Title
Wire Harness, Hydraulics, No-Regen, for LHE
Mellinger

Size B | Document Number <Doc> | Rev C

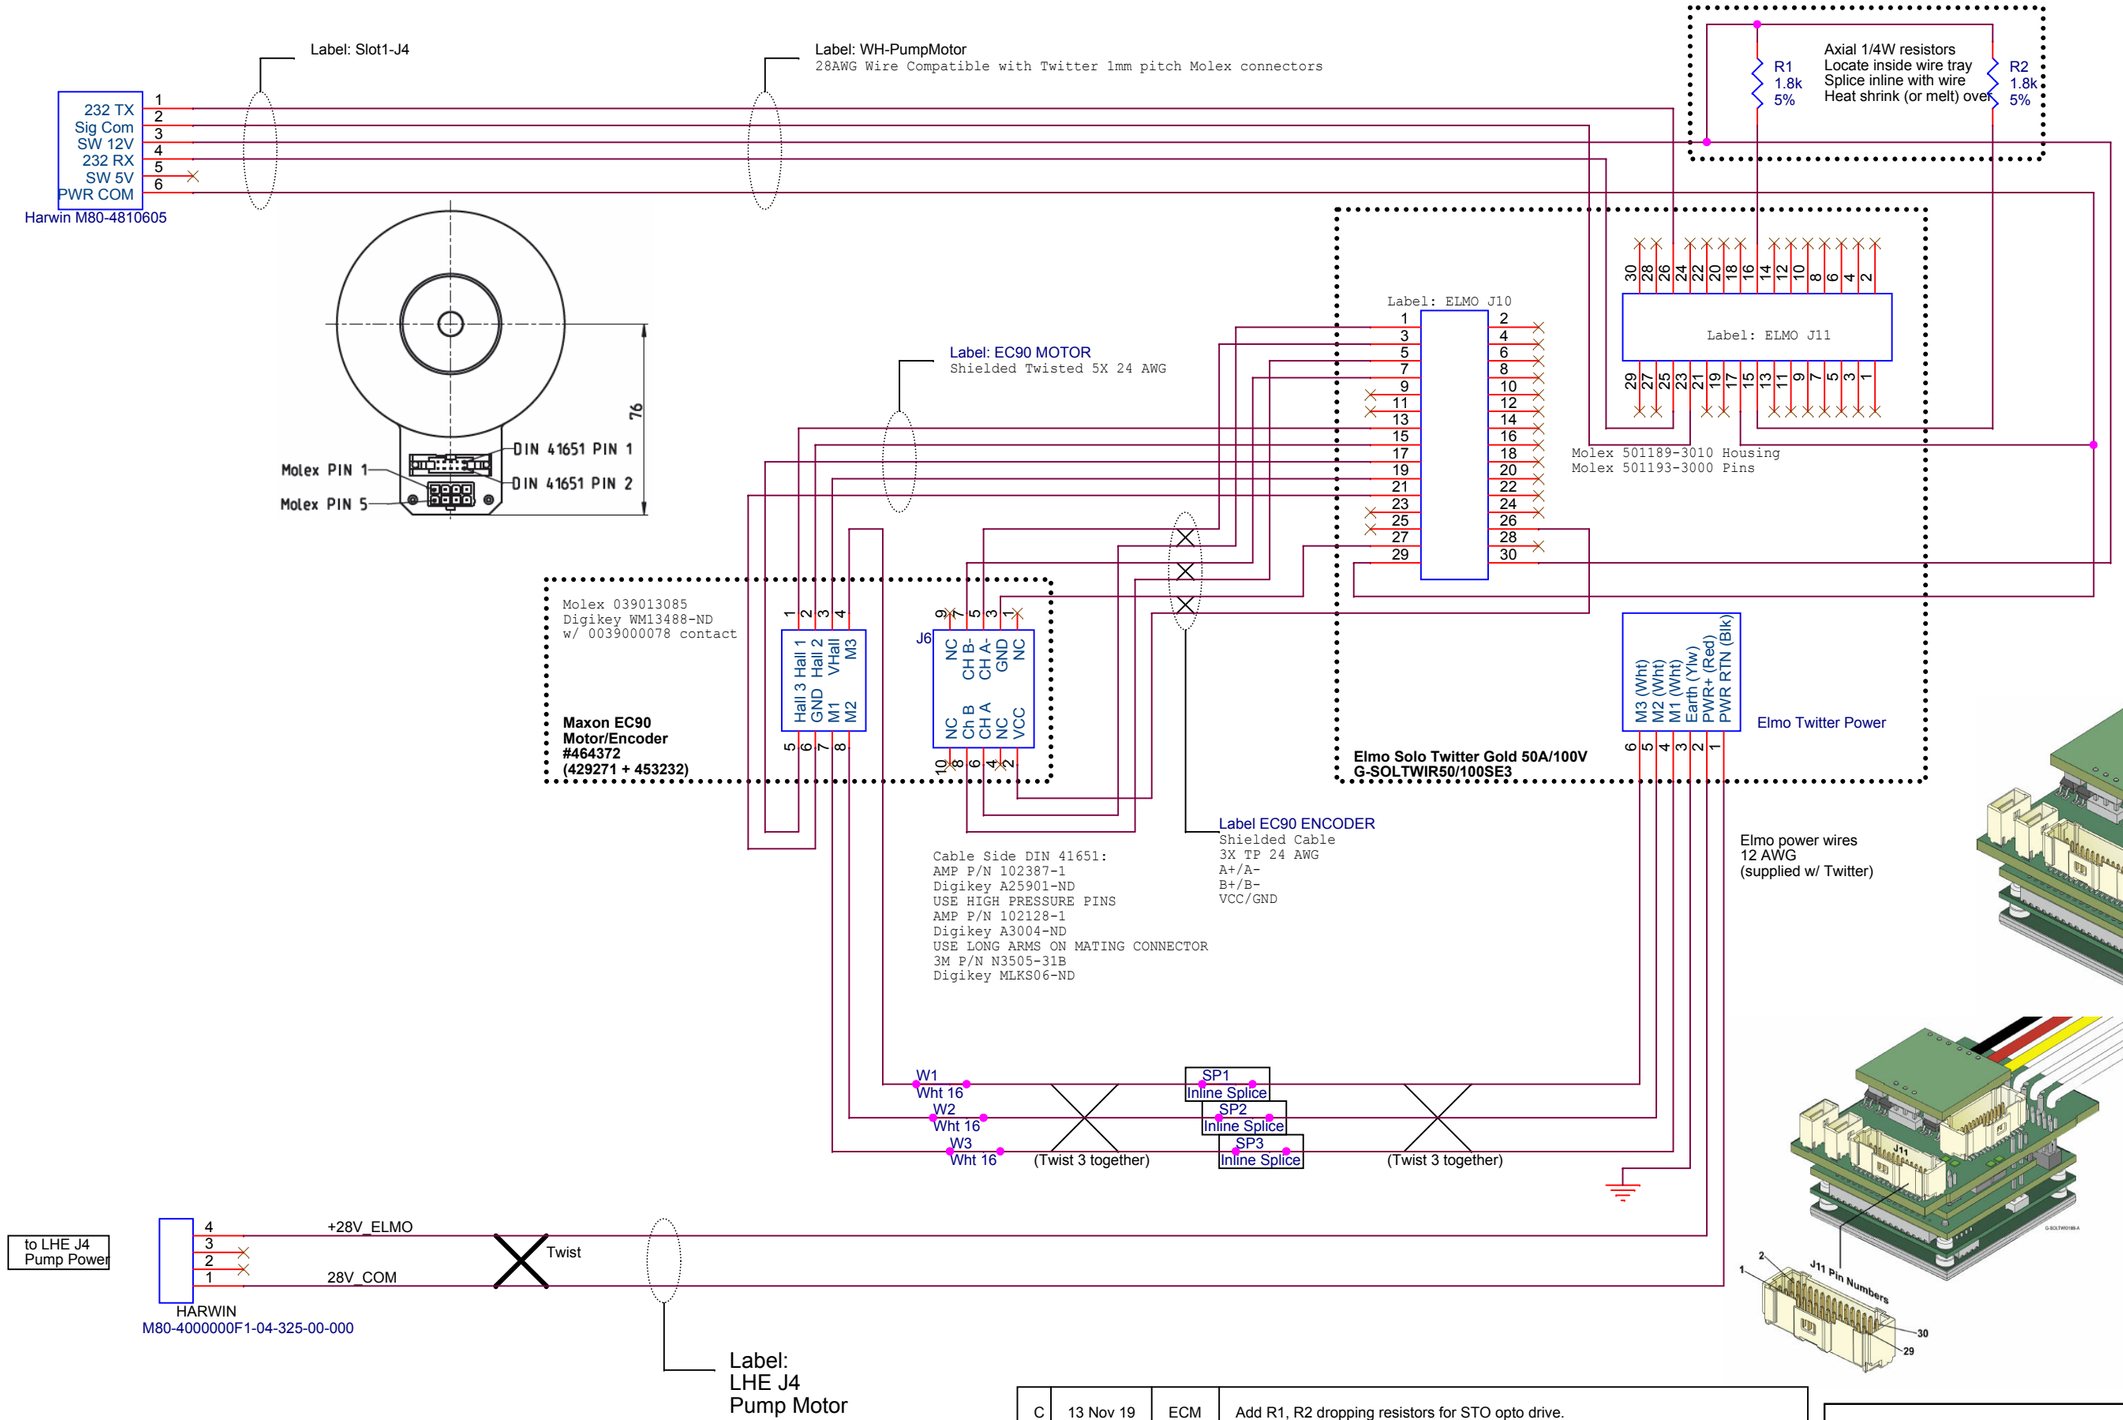
C	13 Nov 19	ECM	Add R1, R2 dropping resistors for STO opto drive.
B	4 Nov 19	ECM	Remove reference to "M80-327 Pin" at Pump Power connector. Redraw Motor-Elmo wiring to show pairs, splices.
A	29 Oct 19	ECM	Reverse polarity of Pump Power connector to LHE
